Docket Number:	11-AFC-01C
Project Title:	Pio Pico Energy Center - Compliance
TN #:	205609
Document Title:	Petition to Amend - Wastewater Tank
Description:	N/A
Filer:	Dale Rundquist
Organization:	California Energy Commission
Submitter Role:	Commission Staff
Submission Date:	7/31/2015 2:49:47 PM
Docketed Date:	7/31/2015

Pio Pico Energy Center, LLC

**Petition to Amend
Wastewater Storage Modification for
Pio Pico Energy Center
(11-AFC-1C)**

July 31, 2015

PLOT PLAN

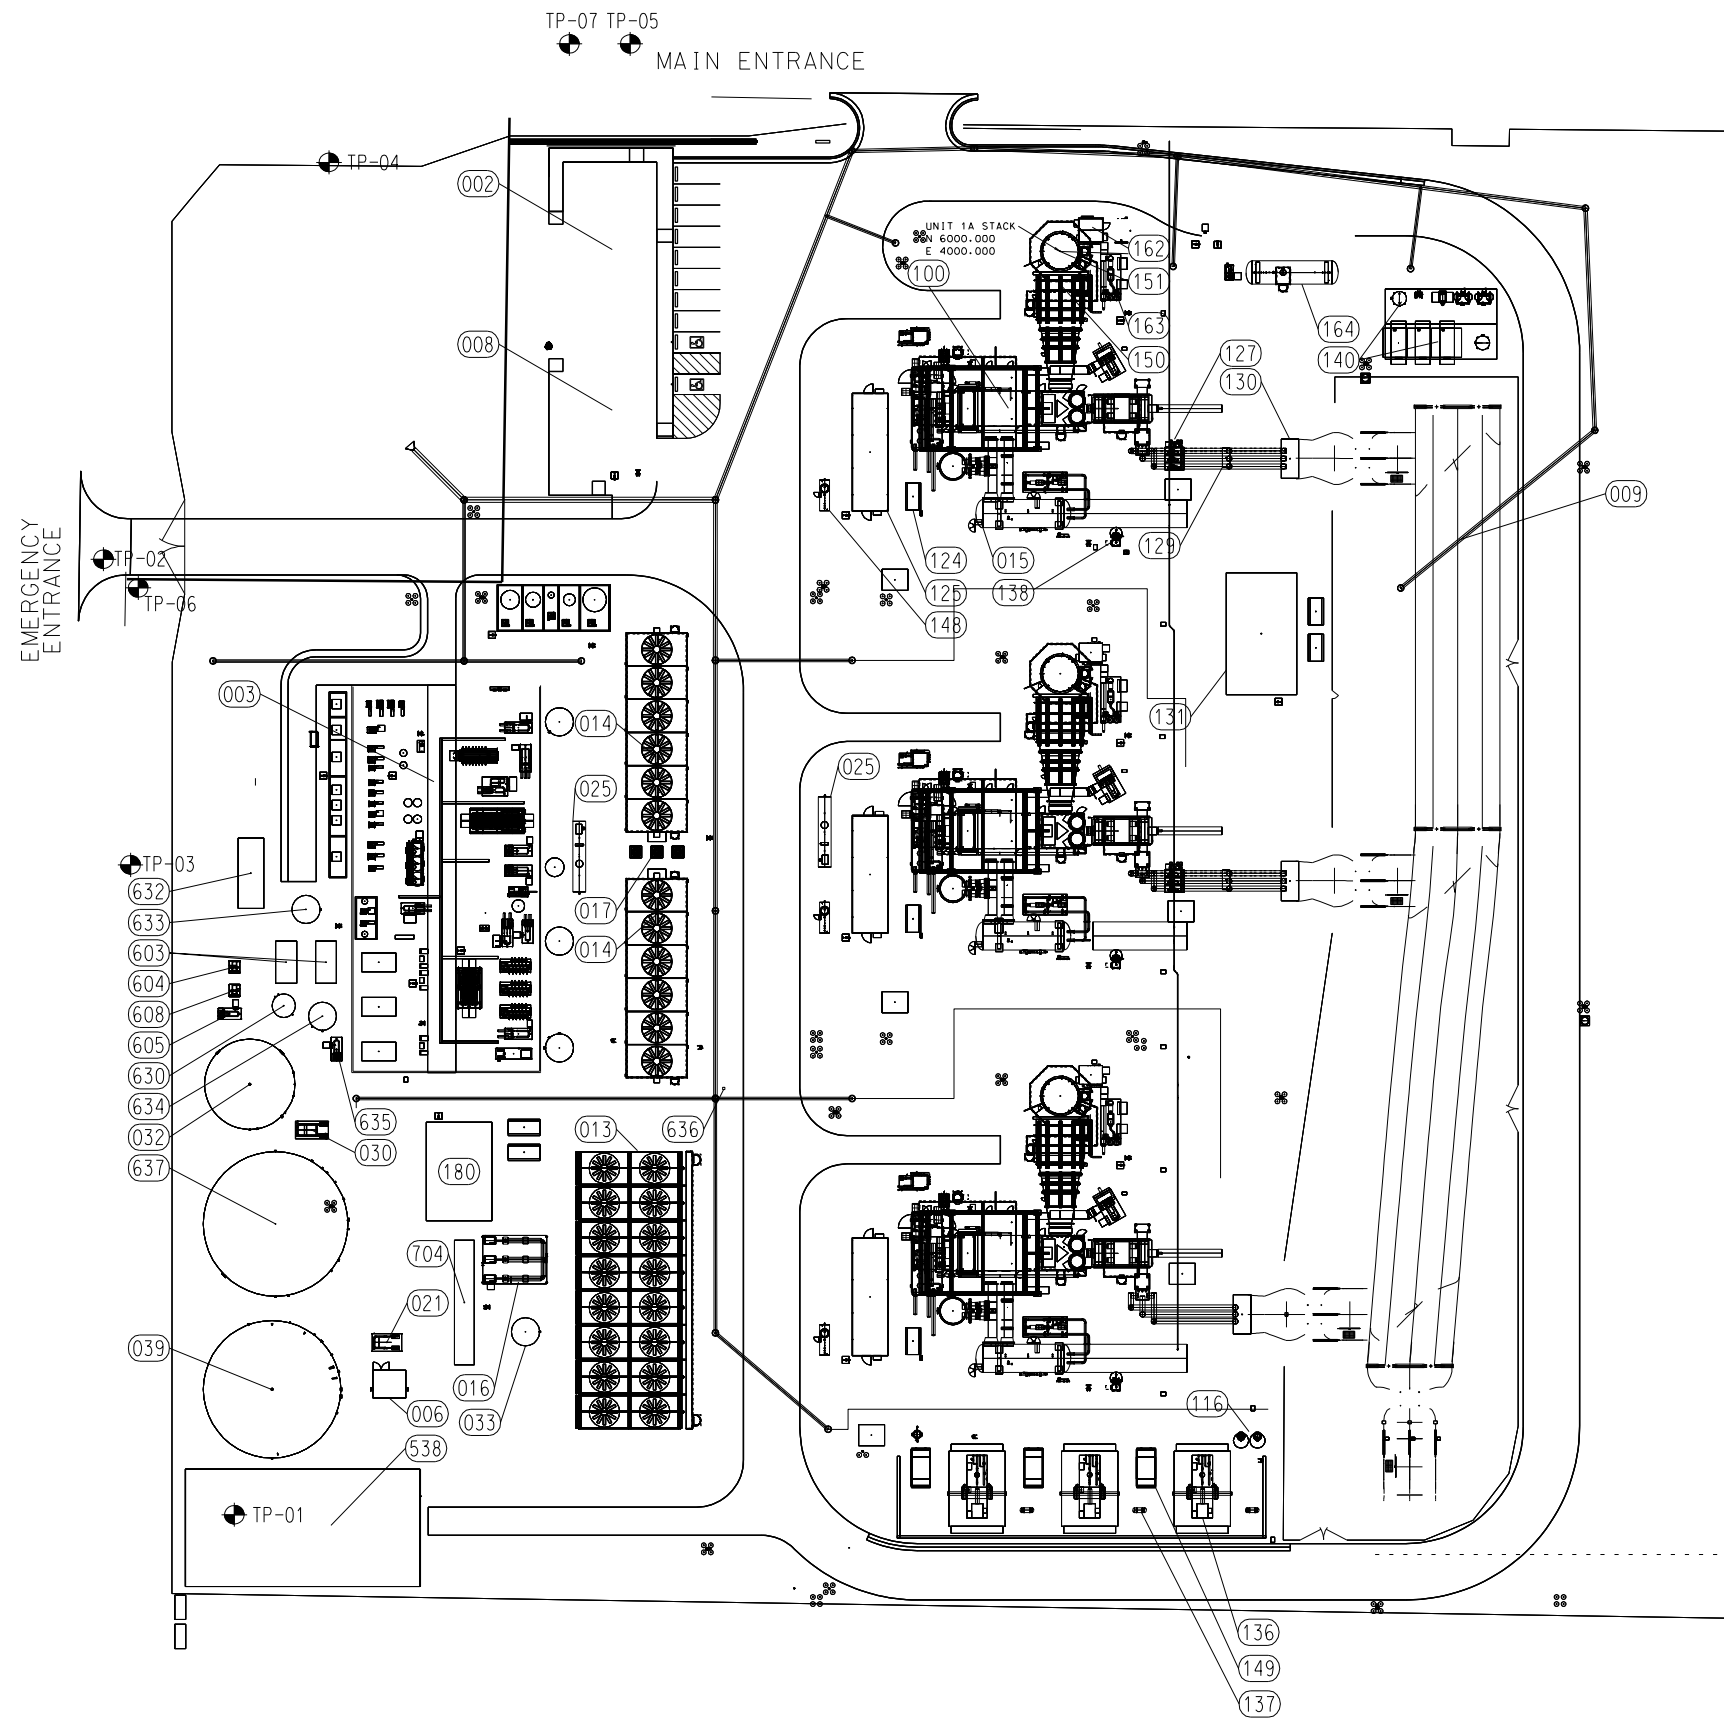
As we discussed on July 2, minor changes are proposed to the water storage tank designs for the Pio Pico Energy Center: the water tanks will be in slightly different locations, and two of the tanks will be increased in size. The Raw Service Water Tank will be increased from 500,000 gallons to 650,000 gallons, and the Process Wastewater Tank will be increased from 95,000 gallons to 500,000 gallons. The tank locations are shown in the attached drawing. The cooling tower design, operation and water quality are assumed to be the same as originally modeled.

The new tank dimensions are provided below.

- (039) Raw water tank: 49'H X 58' dia
- (637) Process wastewater tank" 39'H X 61' dia
